WATER MANAGEMENT PLAN

HERA MINE AND FEDERATION MINE

18/06/2025

FIGURE 16

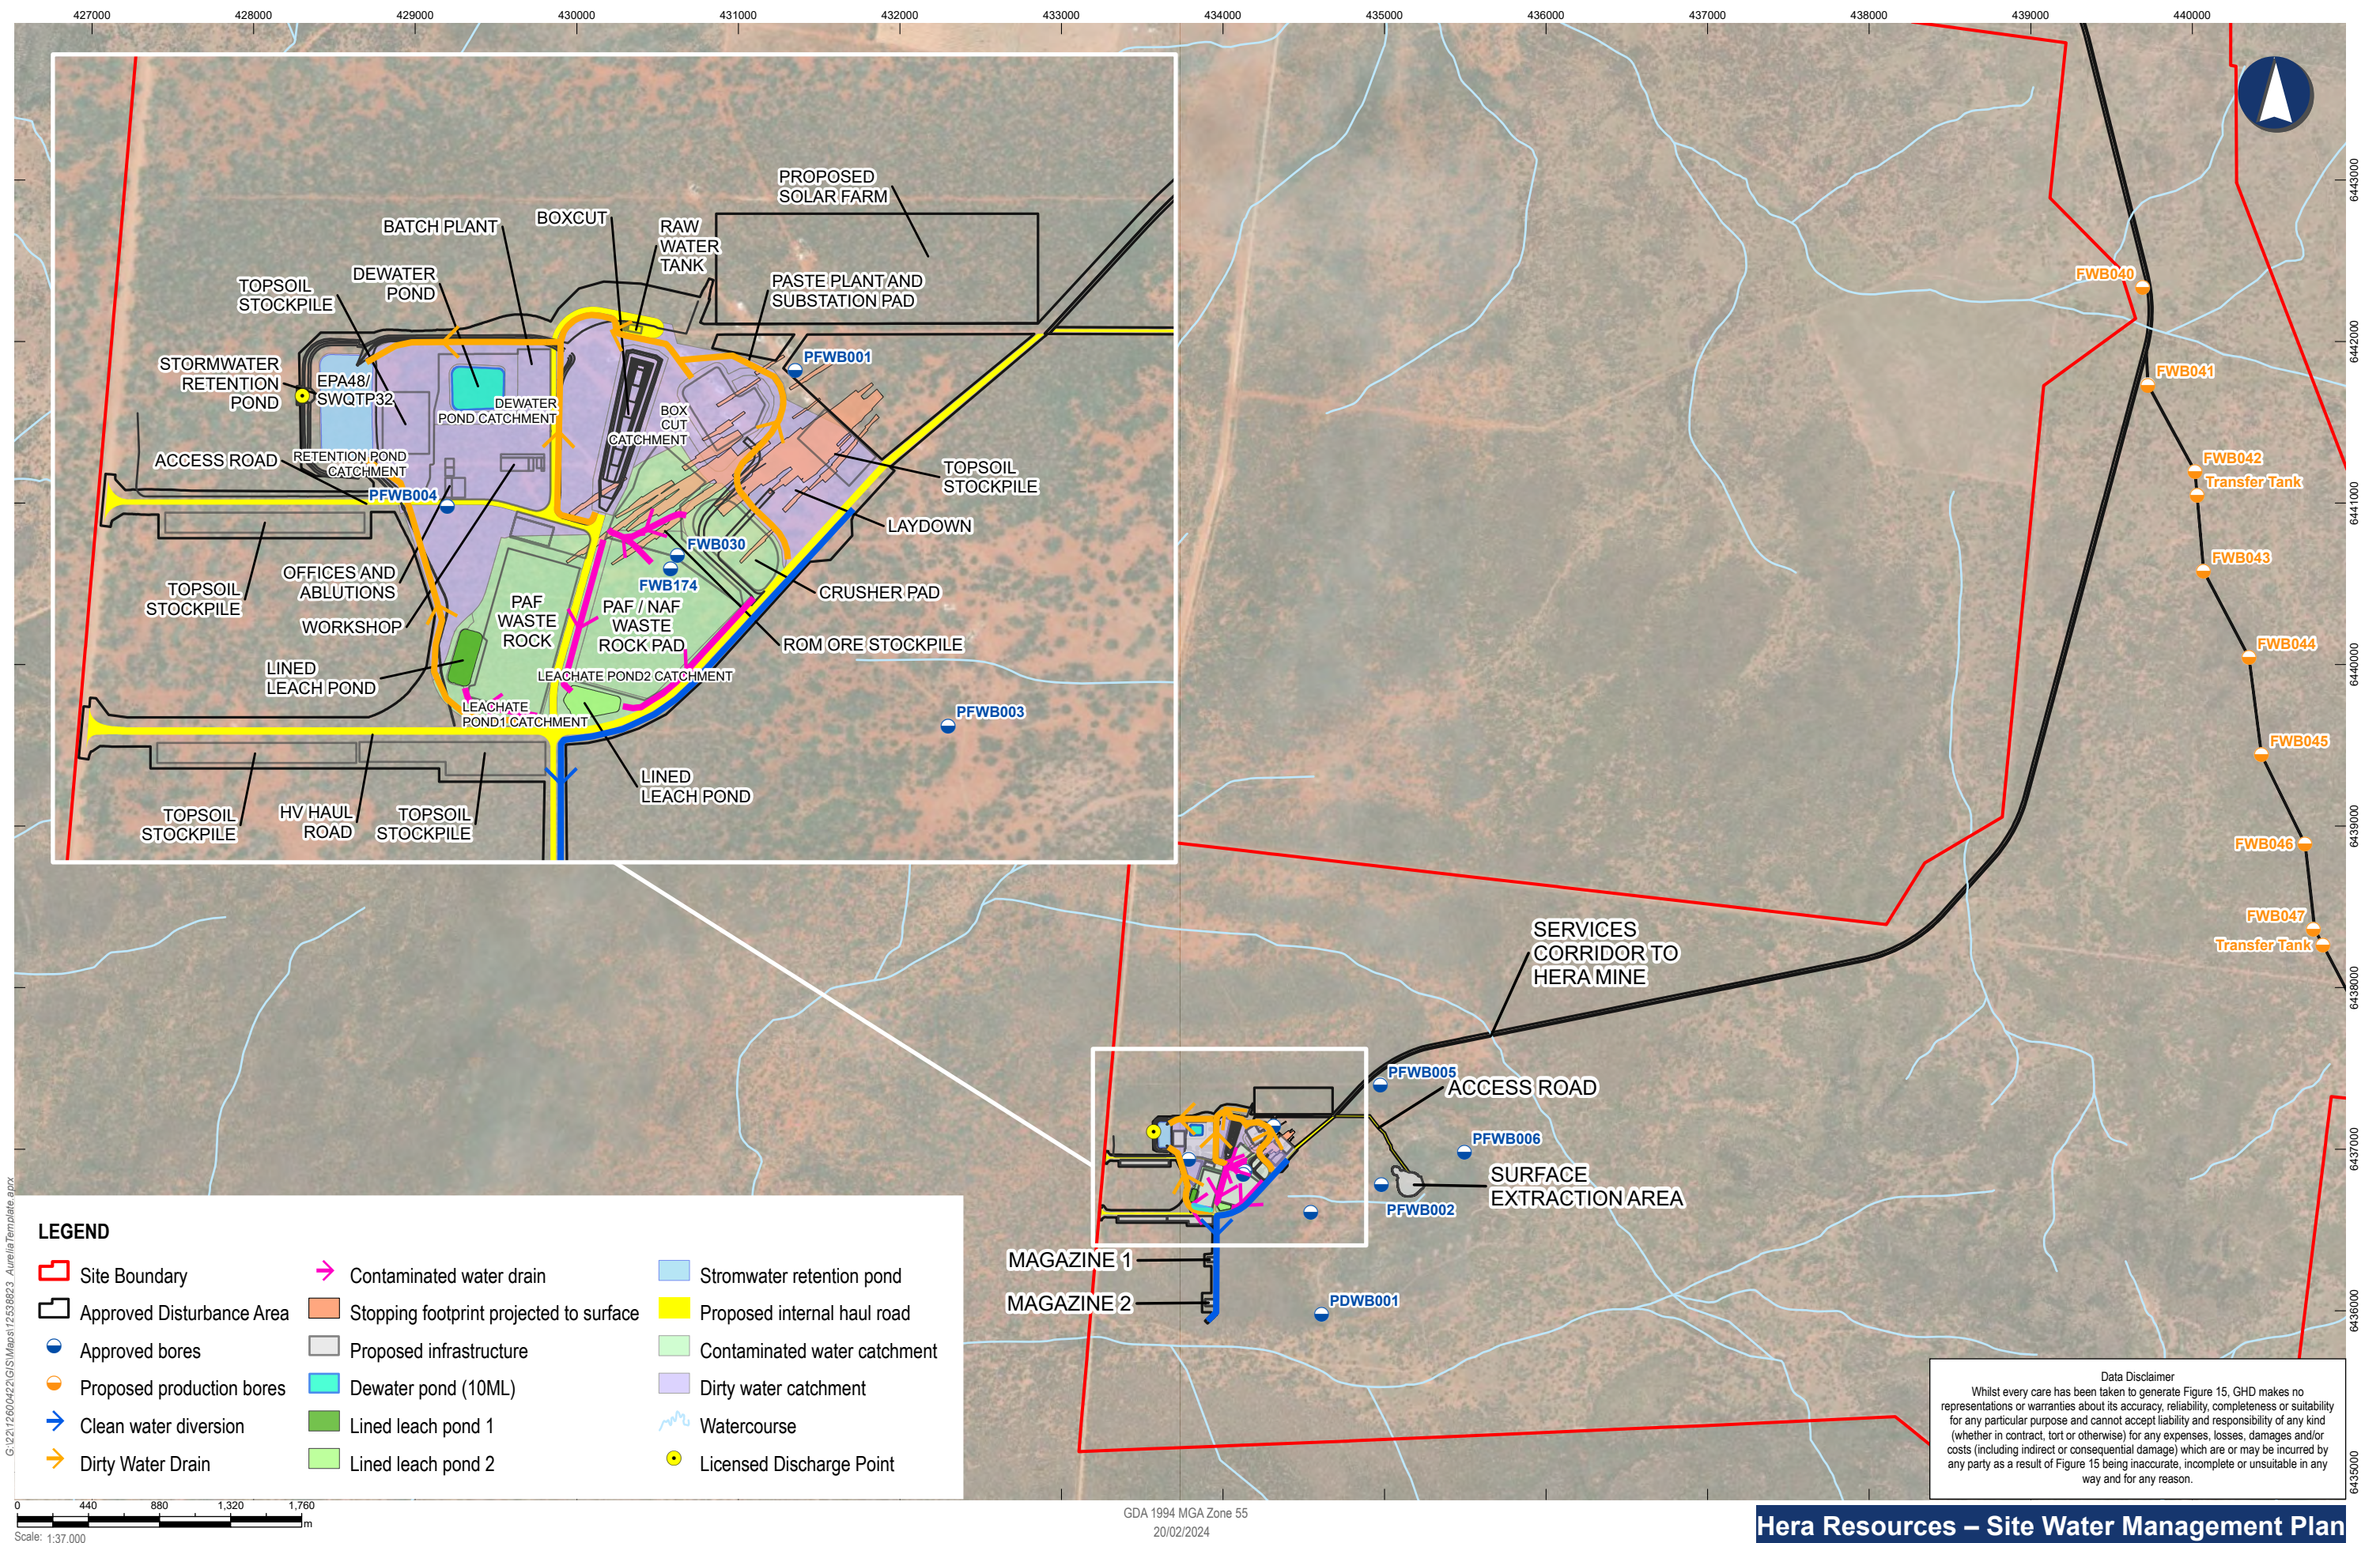
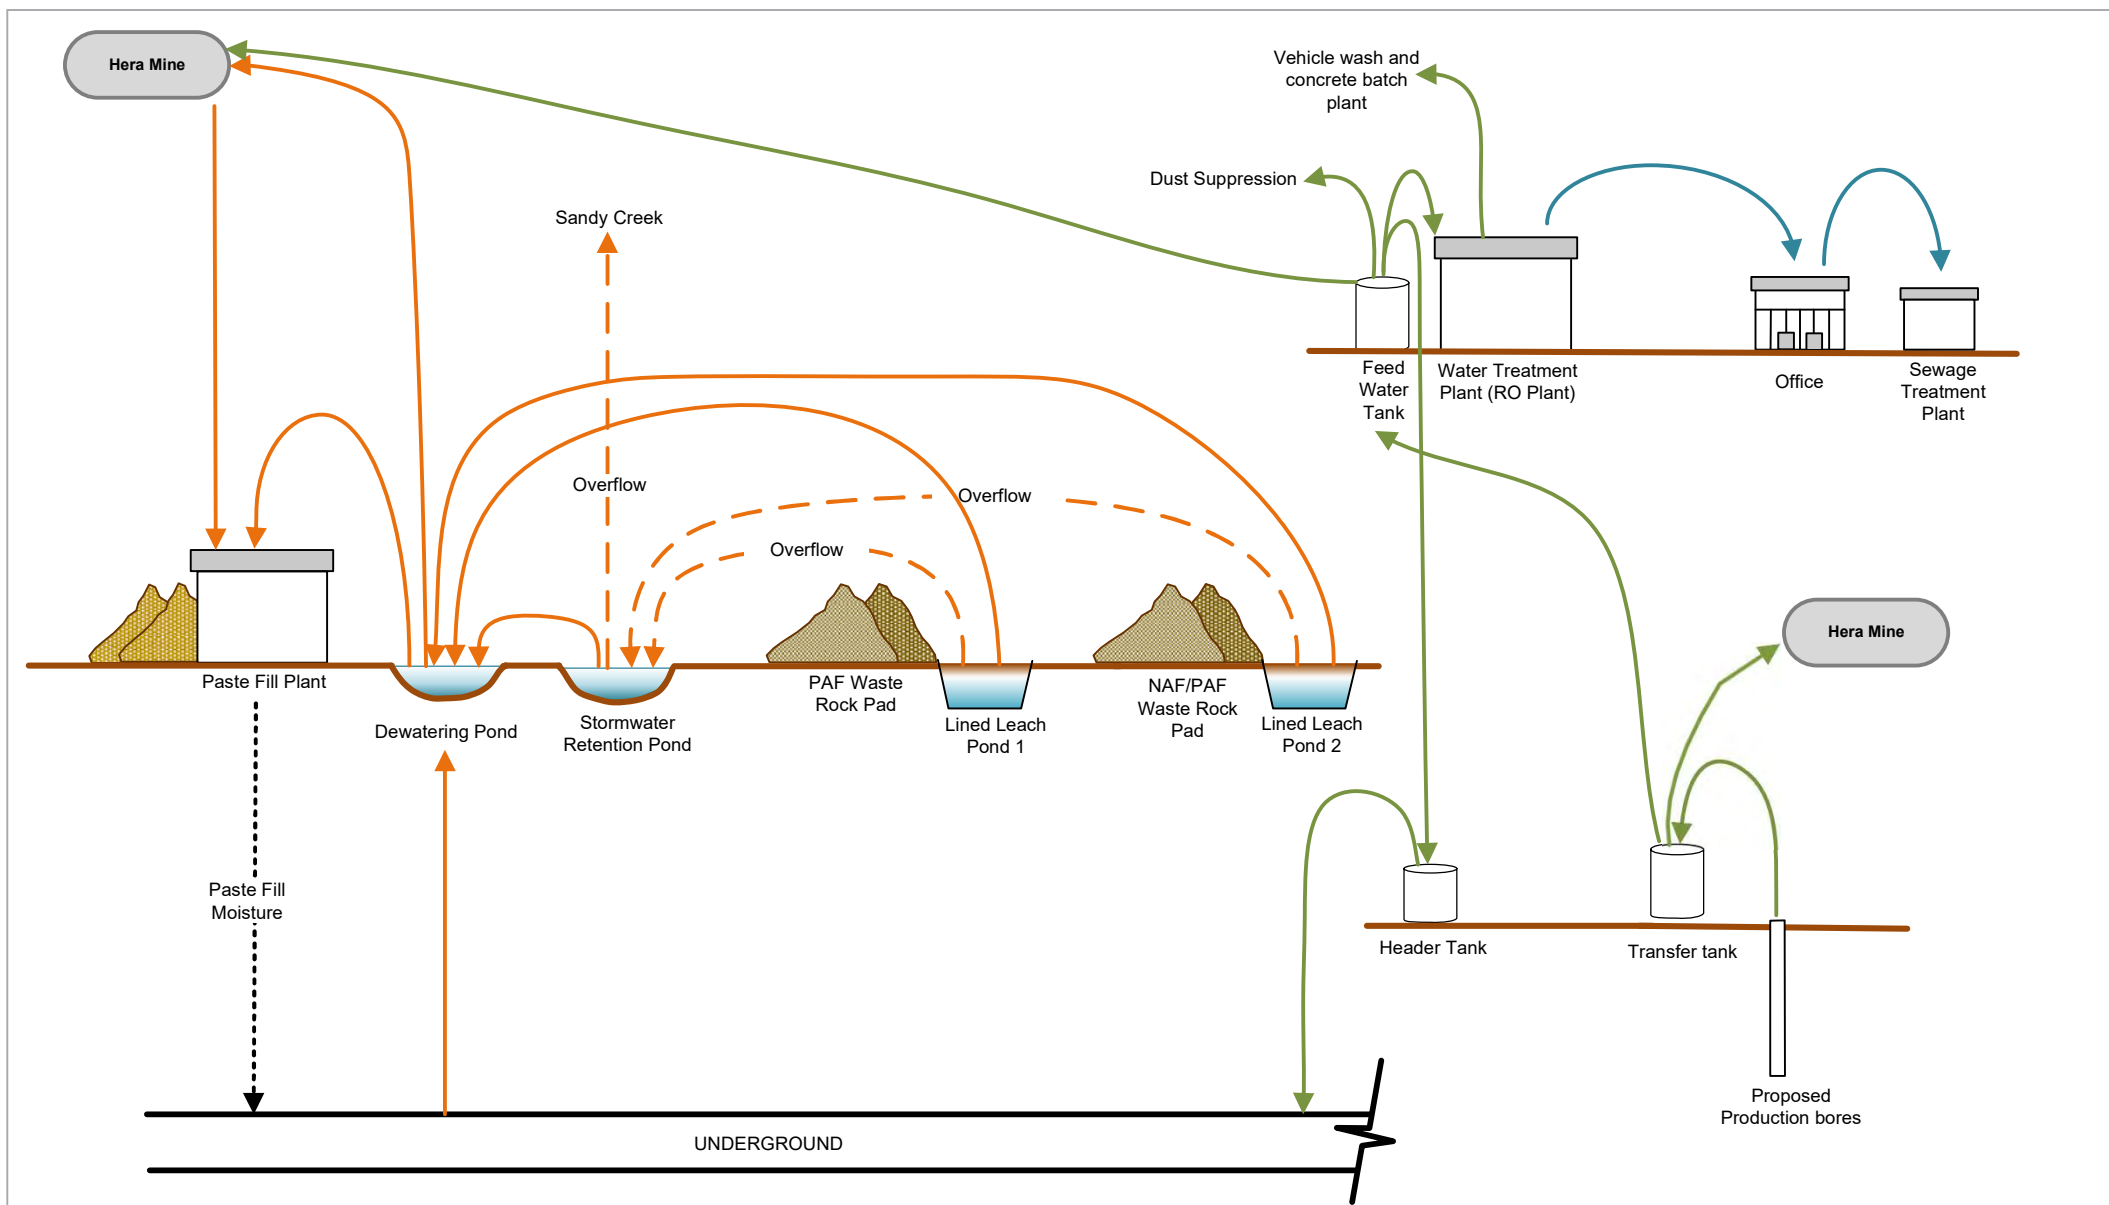
Section 4.2.1 Figure 16	Indicate which flows are metered, which dams have level sensors.	All existing dams have manual read flood gauge. Metered flows include: Extraction from all production bores Back Tank Three Gates Tank Raw Water Tank TSF decant to PWD Gland water
